## PŘÍKAZ K ZACHOVÁNÍ LETOVÉ ZPŮSOBILOSTI

Číslo: CAA-AD-065/2003R1

### VRTULNÍK - SILOVÝ UZEL PŘÍHRADOVÉ KONSTRUKCE DRAKU – KONTROLA/VÝMĚNA

**2003-13-15 R1 Schweizer Aircraft Corporation:** Amendment 39-13709. Docket No. 2002-SW-25-AD.  
Revises AD 2003-13-15, Amendment 39-13217, Docket No. 2002-SW-25-AD.

Figure 1

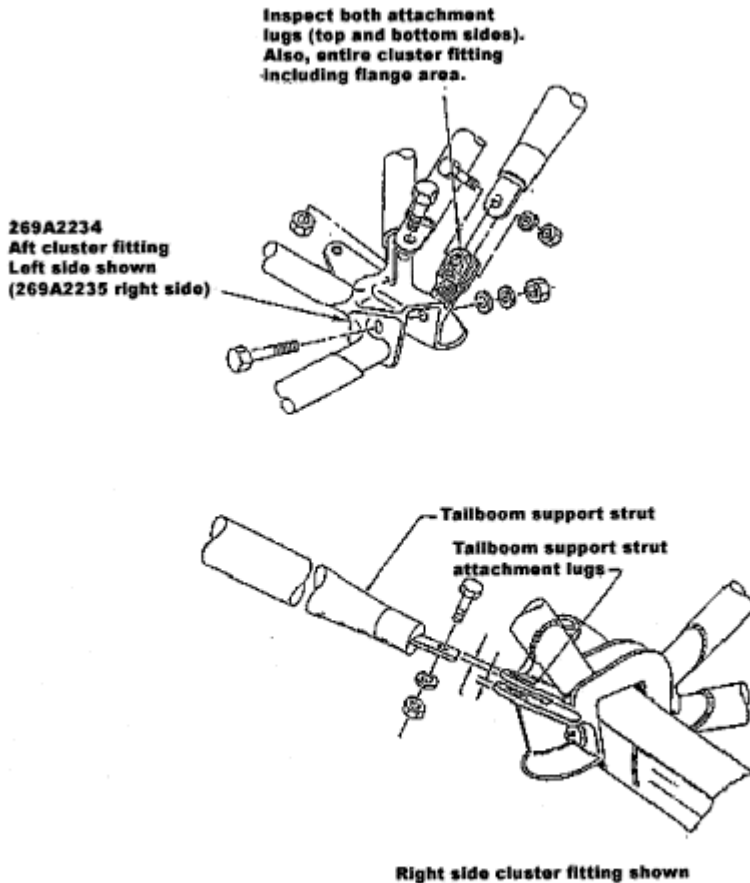
(2) Dye-penetrant inspect the lugs on each cluster fitting. See the following Figure 1:

(3) If a crack is found, before further flight, replace the cracked cluster fitting with an airworthy cluster fitting.
